## **Access Compliance Report Public Rights-of-Way** (Curb Ramps)

Intersection ID: 28228 Main Street: LINDRICK LN **Cross Street: TOM SHORT RD** Location: NW **Overall Compliance: No Severity Score:** ADA ID: 1CB6EF2B19DE Ramp Type: Combination1Diag Initial Pass/Fail: Fail 0

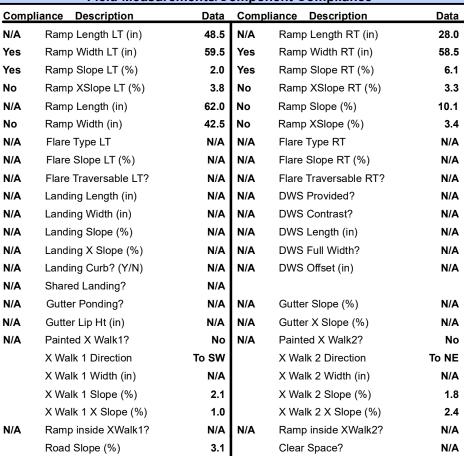
Street 1 Name StopSign Stop Condition-Street 1 LINDRICK LN Street 2 Name Stop Condition-Street 2 TOM SHORT RD Possible Solutions: Remove & Replace Curb Ramp With Two New Directional Ramps or Equivalent. Surveyor Notes: LT RP < 5% PROW/ADA: R304.5.1, R304.2.2, R304.5.3
